**FINAL CLOSURE PLAN
LOPEZ CANYON SANITARY LANDFILL
LAKEVIEW TERRACE, CALIFORNIA**

**VOLUME IV OF IV REPLACEMENT
AMENDMENT TO FINAL CLOSURE PLAN**

Project Number CE4100-06

June 1996

FIGURE NO.	2-2
PROJECT NO.	CE4100-04
DATE:	MAR-21-96

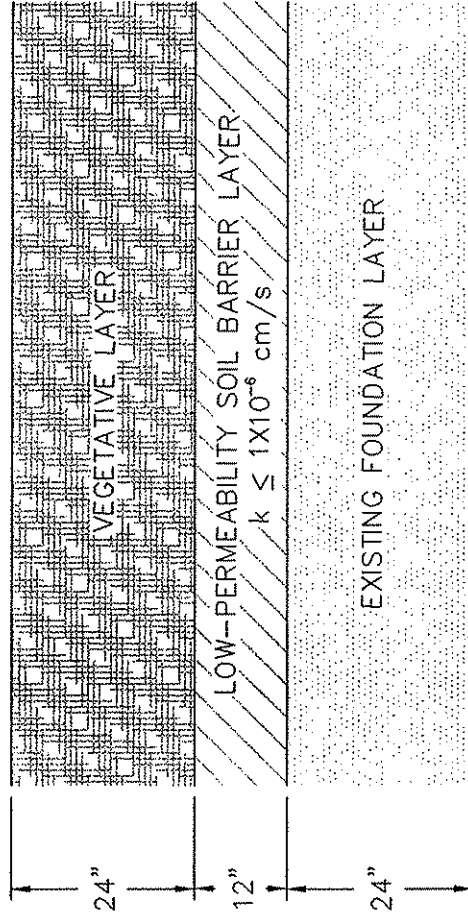
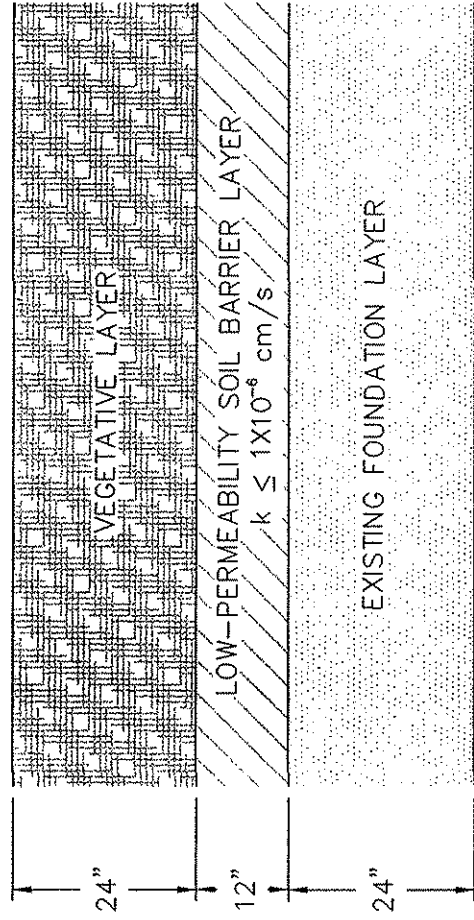
layer and the low-permeability soil barrier layer. In addition, a geosynthetic clay liner (GCL) with a hydraulic conductivity no greater than 5×10^{-9} cm/s may be used as a barrier layer. The use of a GCL will depend on the availability of low-permeability soil. The modified final cover is presented in Figure 2-2.

MODIFIED 02-29-96
TO REMOVE GEOTEXTILE

NOTE: MAY BE REPLACED
BY A GEOSYNTHETIC CLAY
LINER $K \leq 5 \times 10^{-9}$ cm/s

FIGURE NO. 4-1
PROJECT NO. CE4100-04
DATE: APR-26-96

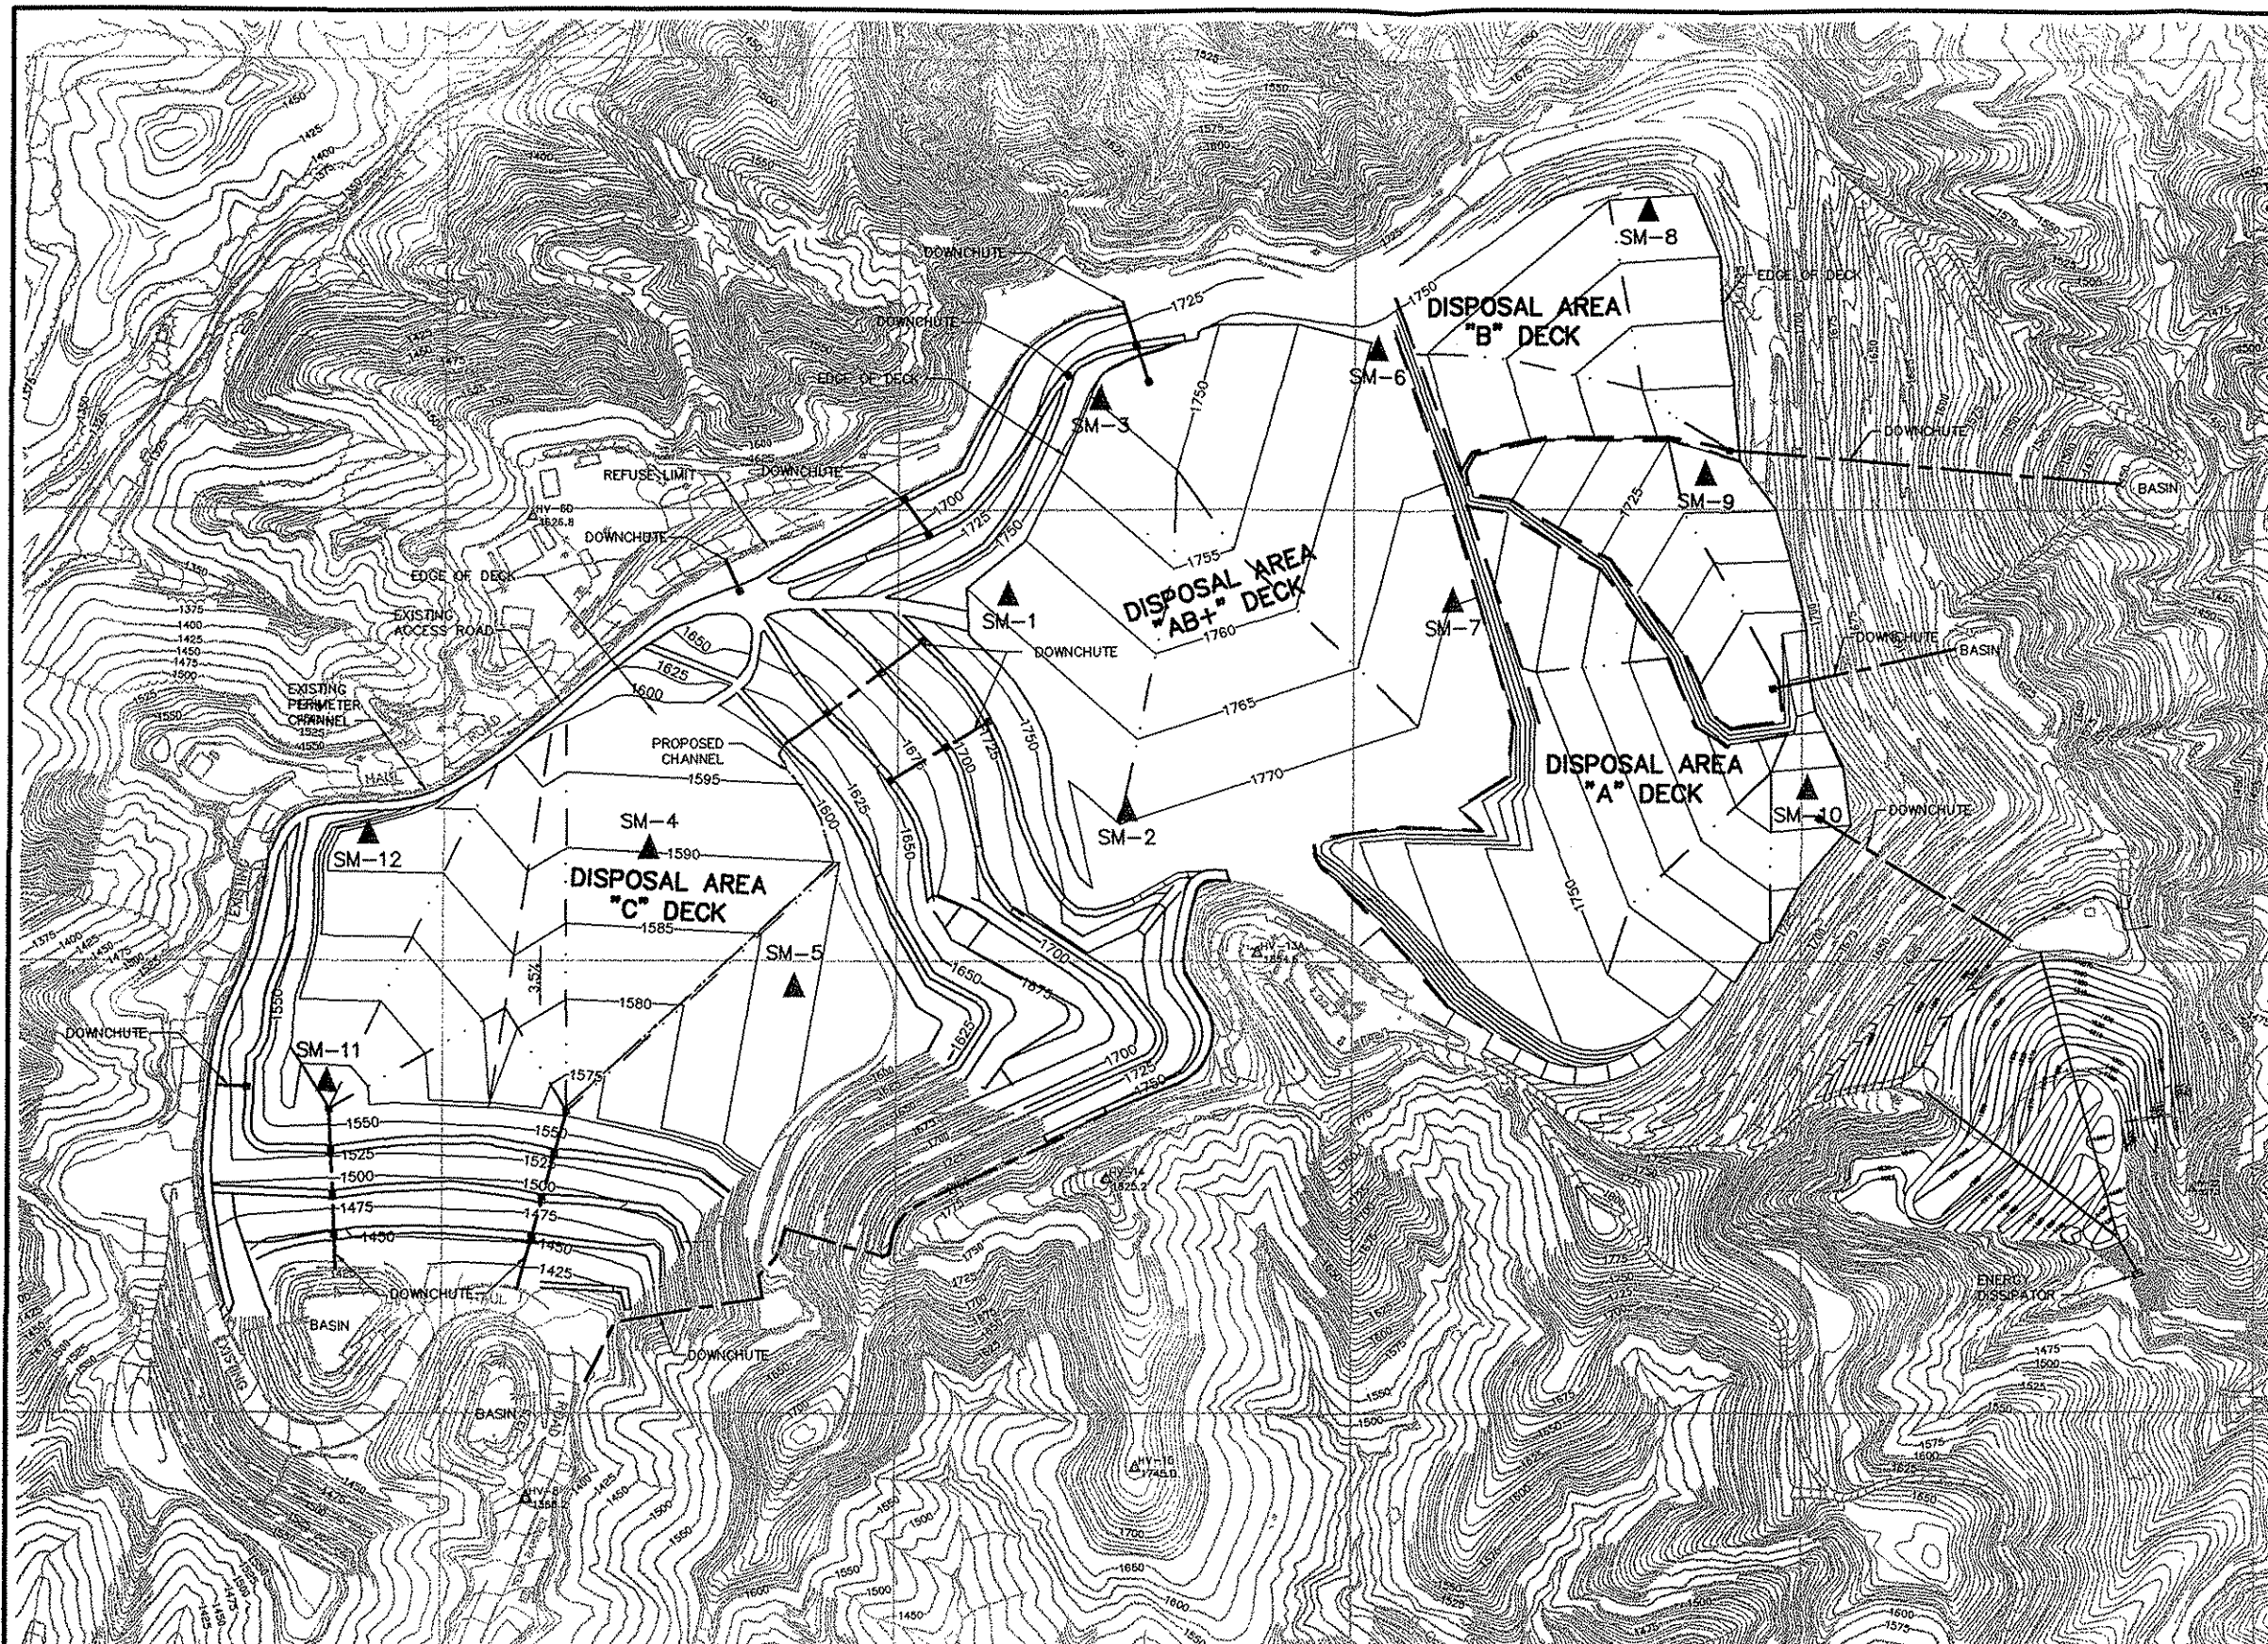
Final cover post-closure settlement estimates were presented in Section 4.8 of the FCP as 30 percent of the total waste thickness. Based on the revised final grading design for Disposal Areas AB+ and C (Figure 3-1, Drawing 1 of this addendum), the bottom liner grading plan for Disposal Area C, and historical topographic maps for Disposal Area AB+, a revised post-closure settlement contour map was developed for Disposal Areas AB+ and C. The revised post-closure settlement contour map is presented as Figure 4-1 and Drawing No. 2 of this amendment.

FIGURE NO. 4-2
PROJECT NO. CE4100-04
DATE: APR-25-96

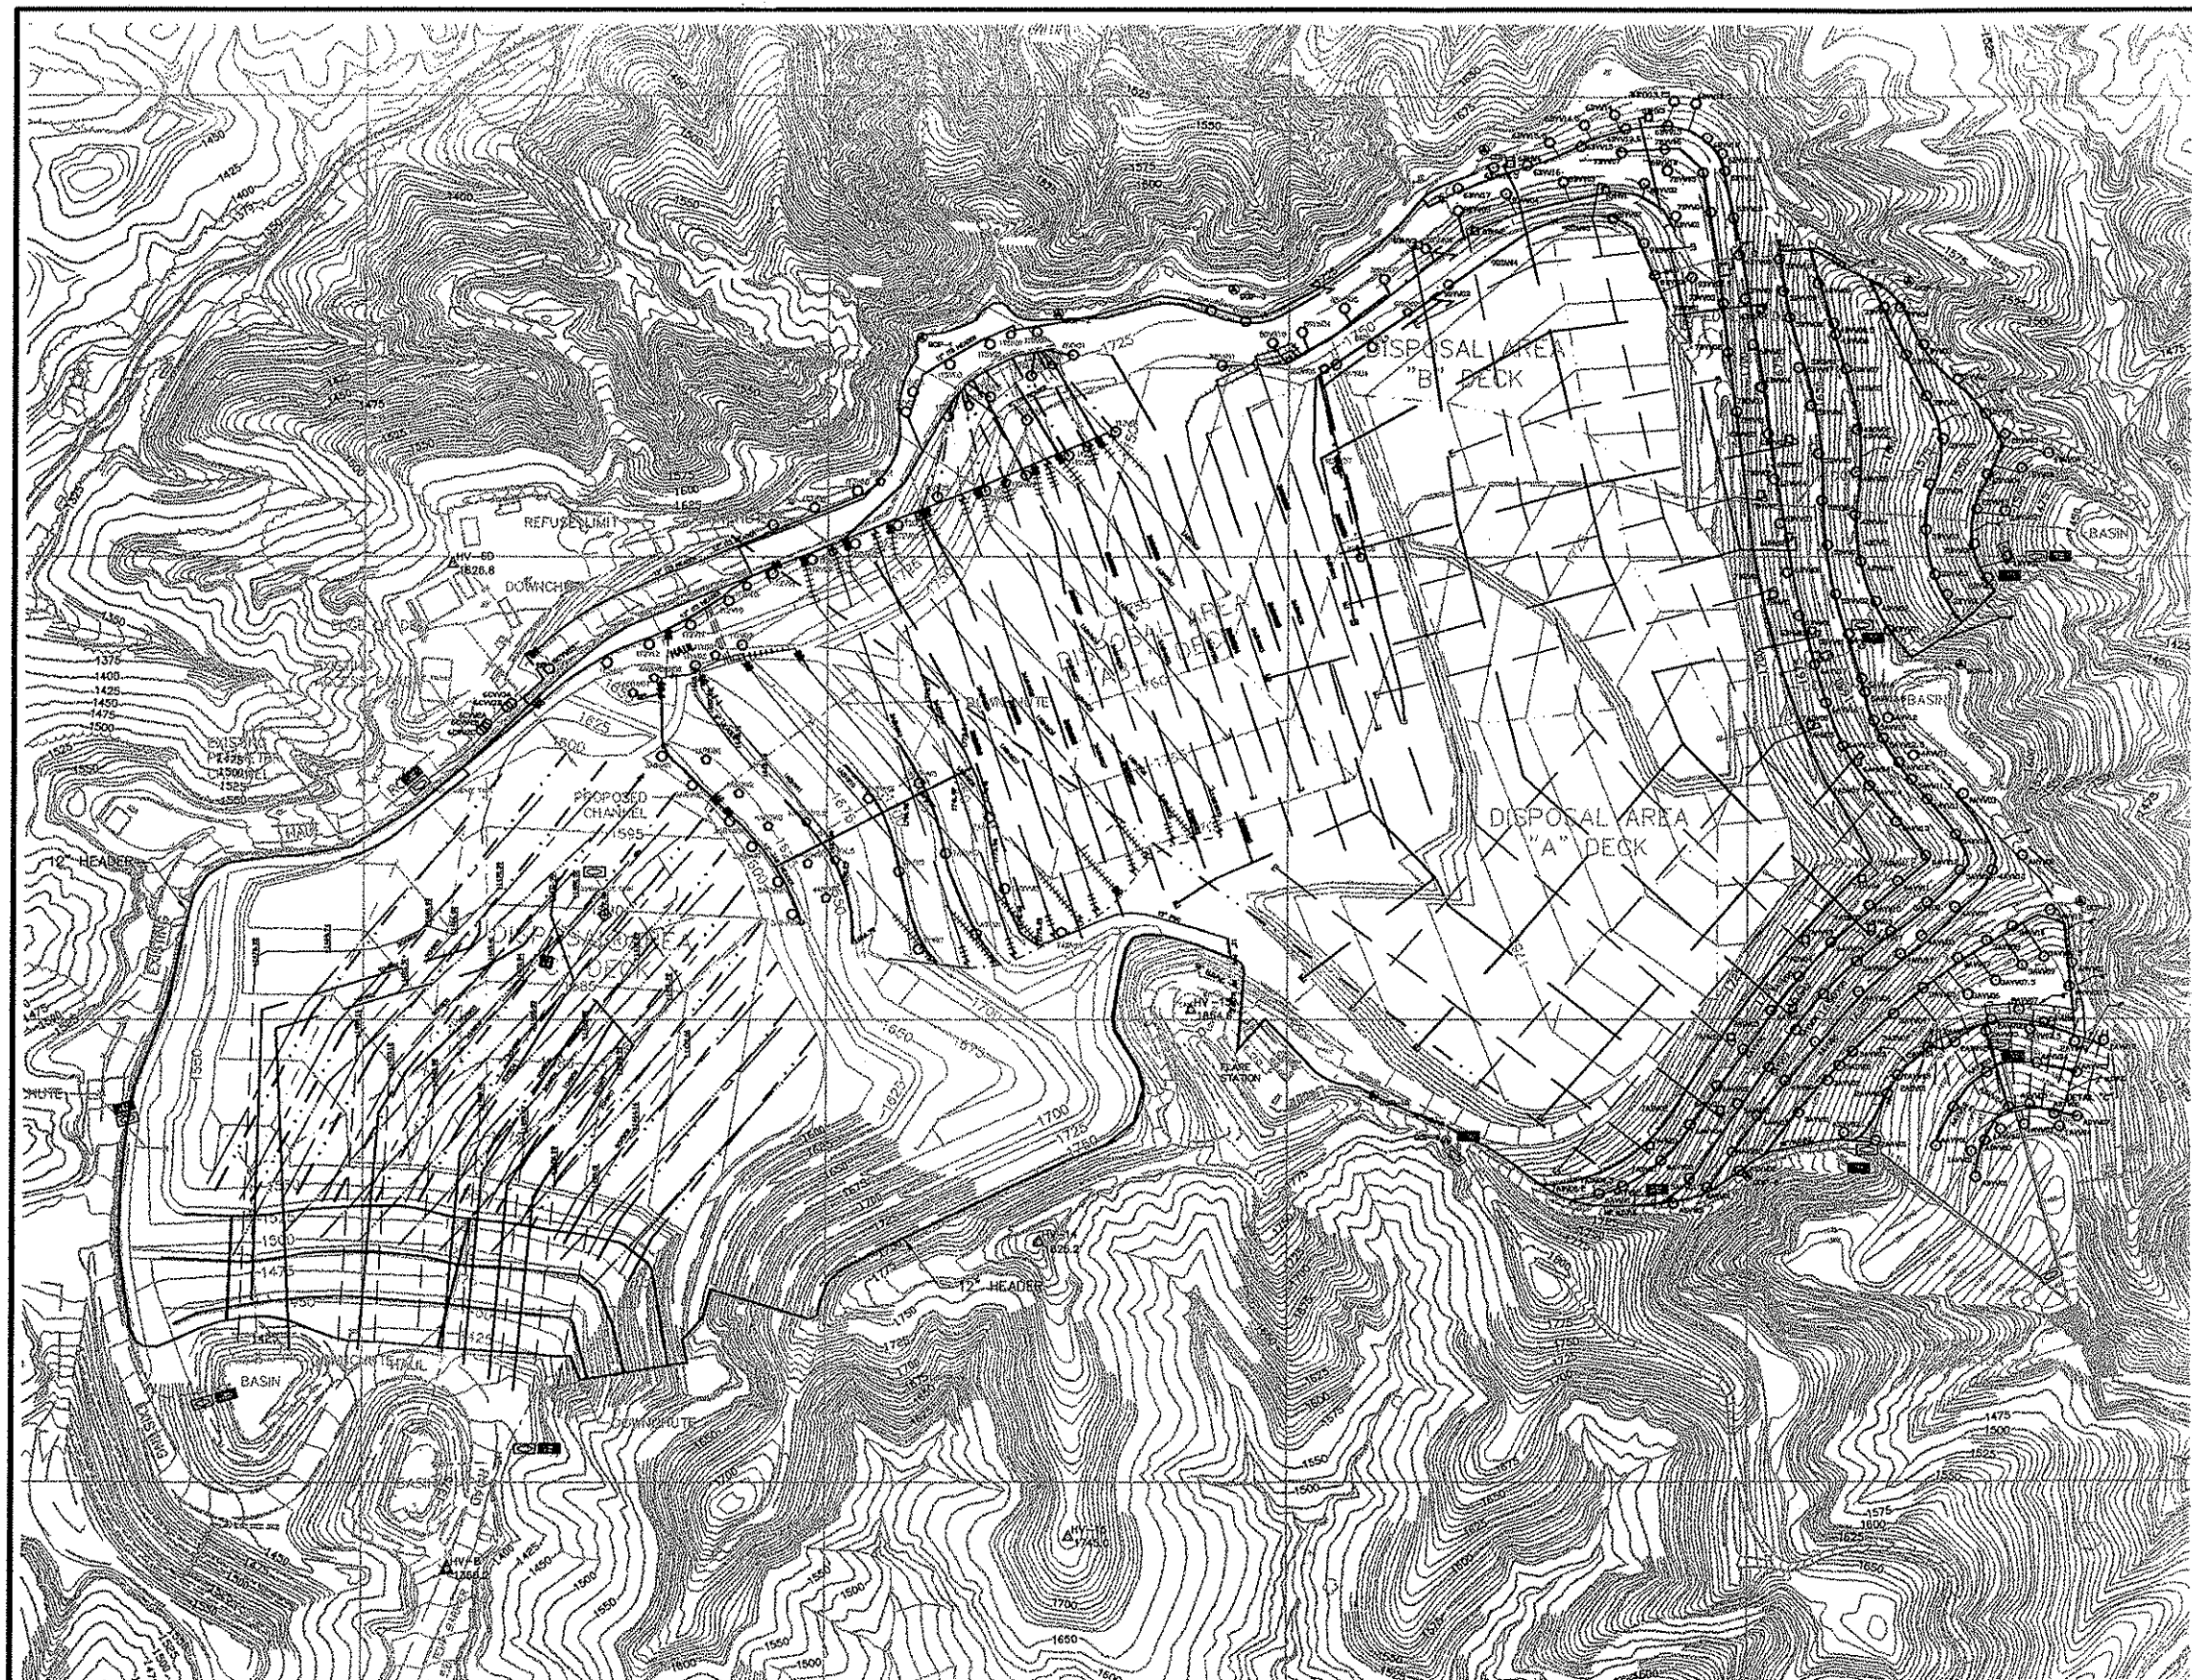
The FCP presented the location of ten settlement monuments. Due to the revisions to the final grading design, several of these settlement monuments were relocated and two additional settlement monuments are proposed. The revised locations of the settlement monuments are presented in Figure 4-2 and Drawing No. 3 of this amendment.
